JOURNAL OF COASTAL AND HYDRAULIC STRUCTURES

Review and rebuttal of the paper

A simple design method for concrete fuse blocks at small
dam spillways

Achary et al.

Figure 1- Close-up of the first 60 seconds of the time series

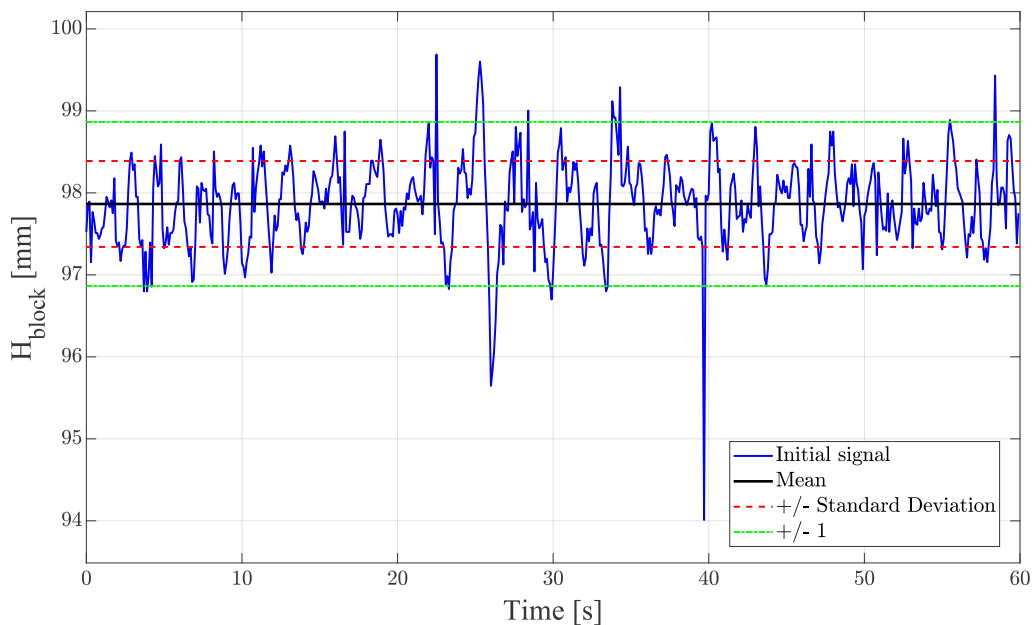
Line 203: Why 13 s? The noise seems to have a regular frequency. Could it be an oscillation in the experimental reservoir? If so, velocity head in your data may not be negligible. Please show a close-up of the time series and maybe a FFT to allow checking for frequency contents.

As for the oscillations, we have examined the amplitude of these fluctuations in the close-up of the first 60 seconds of the time series (see below) and found that their amplitude is of the same order of magnitude as the uncertainty in the positioning of the sensors (on the order of millimetres). This is why these oscillations were not considered in the analysis.
